Addendum No. 01

Subject: **R. Morris Classroom Modernization Project
B-043C, B-044C of 2018/19**

Location: **Robert Morris School
2600 W. Thompson Street
Philadelphia, PA 19121**

This Addendum, dated February 28, 2019, shall modify and become part of the Contract Documents for the work of this project. Any items not mentioned herein, or affected by, shall be performed strictly in accordance with the original documents.

1
E5.1
PARTIAL POWER RISER DIAGRAM
NTS

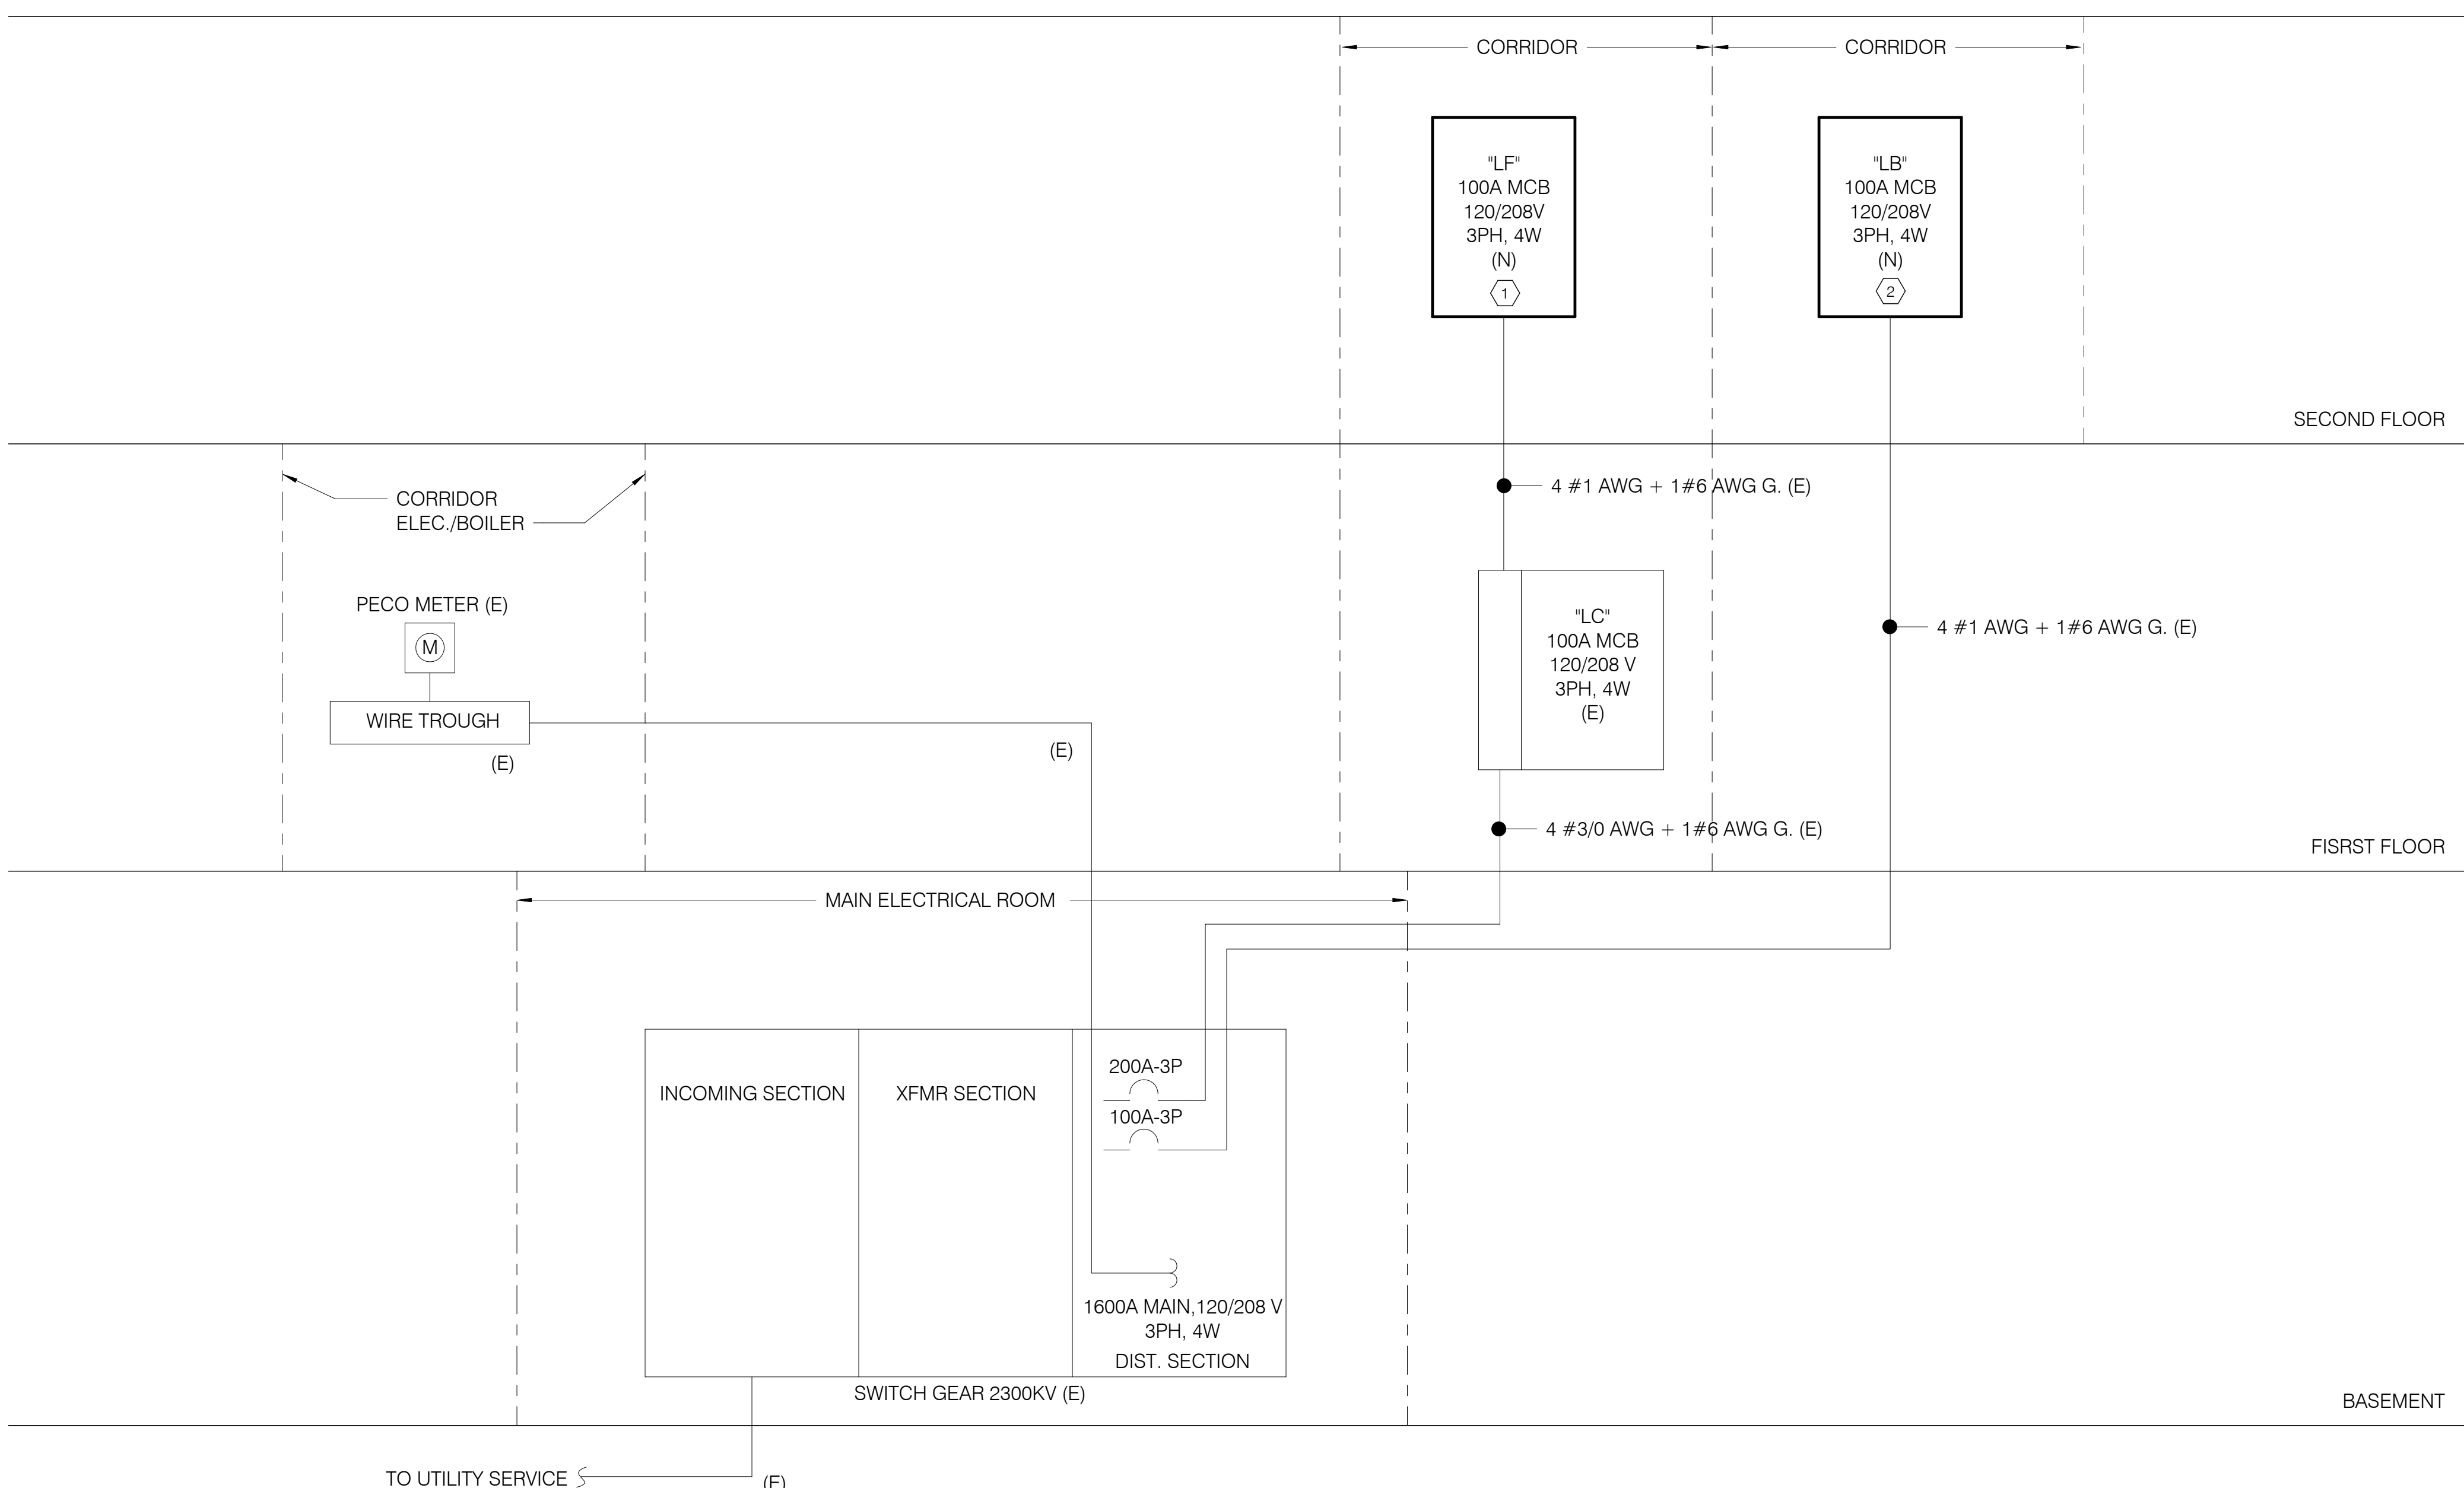
12. Question: Are new panels LF and LB custom built retrofits? Were measurements taken of the existing backbox?

Response: The existing back boxes for Panels LF & LB are approximately 16"W x 4.5" D x 48" H. Provide new 54 pole panelboard with the dimensions 20"W x 5.75"D x 60" H. Electrical Contractor to cut existing wall as required to fit new panelboard, patch and paint wall to match adjacent existing wall finish. Refer to revised electrical drawings, attached.

1. EXISTING RECESSED BRANCH DISTRIBUTION PANEL "LF" TO BE DEMOLISHED AND REPLACED IN PLACE WITH NEW RECESSED 100A MCB, 120/208V, 3PH, 4W, 64 POLE PANEL. CONTRACTOR TO VERIFY AND MATCH NEW PANEL RATINGS TO EXISTING. ALL CIRCUIT BREAKER RATINGS AND CONFIGURATION OF NEW PANEL TO MATCH EXISTING PANEL. INTERCEPT AND EXTEND ALL ASSOCIATED CONDUITS AND ACTIVE BRANCH CIRCUIT WIRING TO RECONNECT TO NEW PANEL AS REQUIRED.
2. EXISTING RECESSED BRANCH DISTRIBUTION PANEL "LB" TO BE DEMOLISHED AND REPLACED IN PLACE WITH NEW RECESSED 100A MCB, 120/208V, 3PH, 4W, 64 POLE PANEL. CONTRACTOR TO VERIFY AND MATCH NEW PANEL RATINGS TO EXISTING. ALL CIRCUIT BREAKER RATINGS AND CONFIGURATION OF NEW PANEL TO MATCH EXISTING PANEL. INTERCEPT AND EXTEND ALL ASSOCIATED CONDUITS AND ACTIVE BRANCH CIRCUIT WIRING TO RECONNECT TO NEW PANEL AS REQUIRED.
